## SECTION 009113 – ADDENDA ONE

- A. Project Name: < **Maine Criminal Justice Academy | Phase One Façade Restoration** >
- B. Owner: < **Maine Criminal Justice Academy** >.
- C. Owner Project Number: < TBA >.
- D. Architect: < **LeMessurier Consultants** >.
- E. Architect Project Number: < **21.0240.001** >.
- F. Date of Addendum: < **September 28, 2022** >.

**Schematic photo-map of MCJA Campus ( see Page 8 for map)**

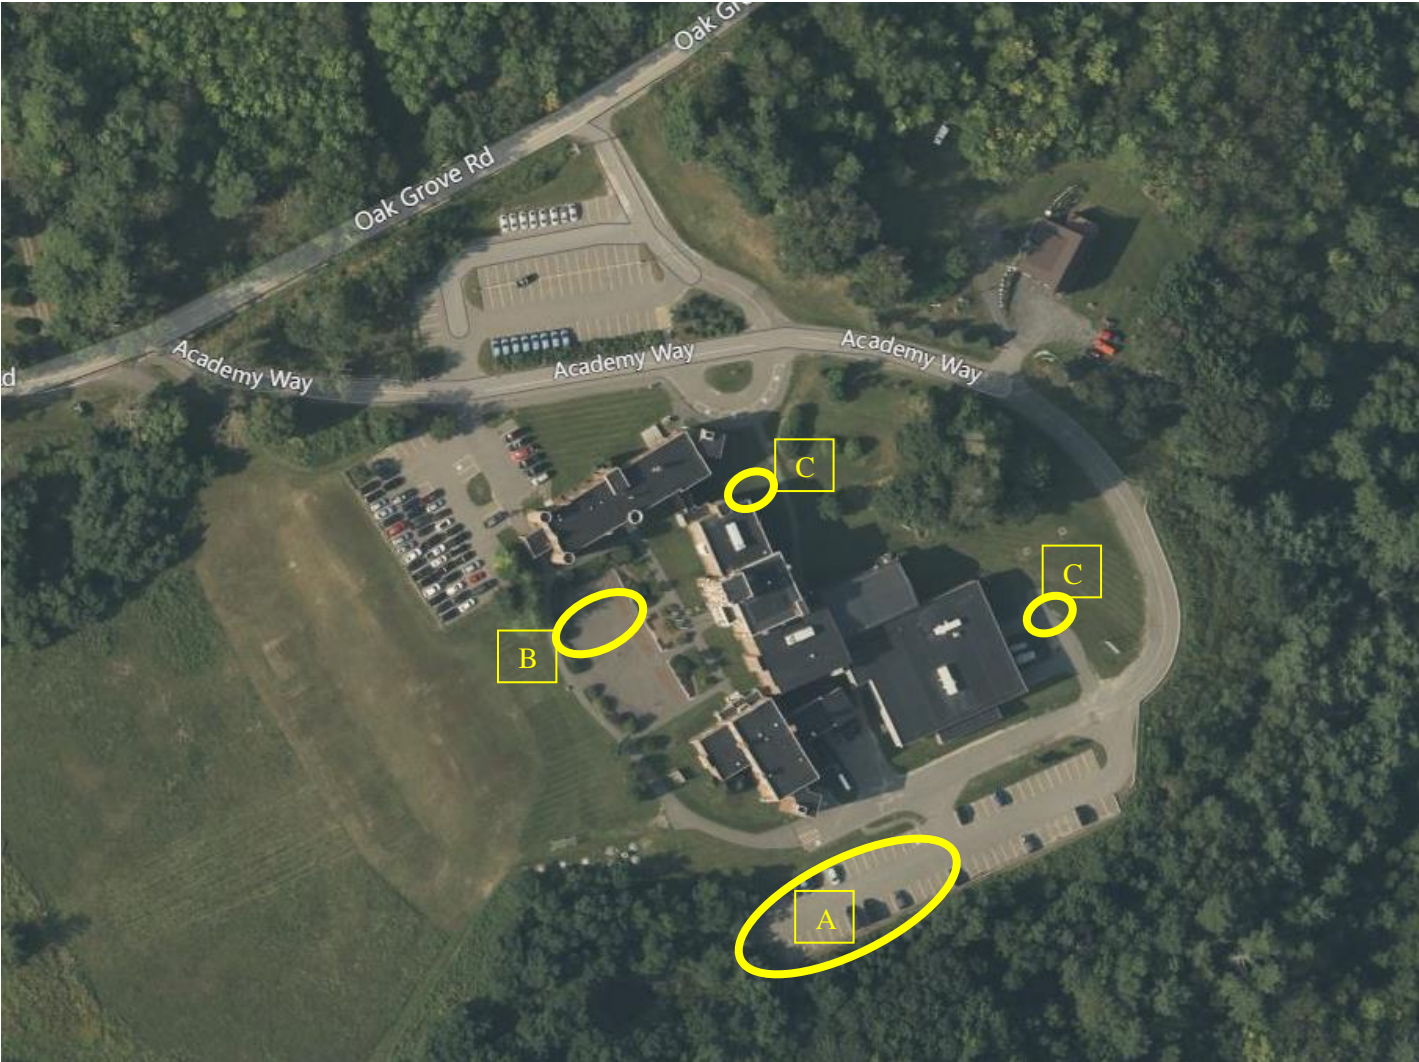
12. QUESTION; A lot of conversation has gone around related to electrical and water requirements for this project. Water will be needed within a 100' of where any of the work is occurring and electrical will vary in each area depending on the contractor. But several at least 3, 30- amp circuits should be less that 100 feet for any area that is being worked on. In some cases, a 220 circuit may be required. If the contractors are required to carry the cost for connecting to the permanent power to get to each area, then we need to know what is available where. Please advise

20. QUESTION: Will there be a spot on site to keep dumpster for daily clean up?

Basis of design for providing temporary services and areas is based on limited contractor information at time of bidding. As result, below is approximate with exception to defined areas A, B, C and contractor parking and deliveries, subject to coordination with owner and or for short durations relocation for use.

1. Power is accessible to most sides of the building via windows, or other. Additionally, Owner to provide temporary power to areas A,B, and C subject to limitations as contractor needs are not accurately known.

2. Water is accessible to all 4 major sides of the building configuration, additional water access to be provided, but limited to availability and contractors equipment requirements.

3. Area A
  - a. Deliveries
  - b. Temp toilet “port-a-potties”
  - c. Storage /staging / prep area
  - d. Construction trailer
    - i. Signage at entry from academy directed construction related work to area A and construction trailer

- e. Contractor Parking
4. Area B and C limited based on access from side walk or rear parking lot access, coordinate with owner
  - a. Storage /staging/prep area
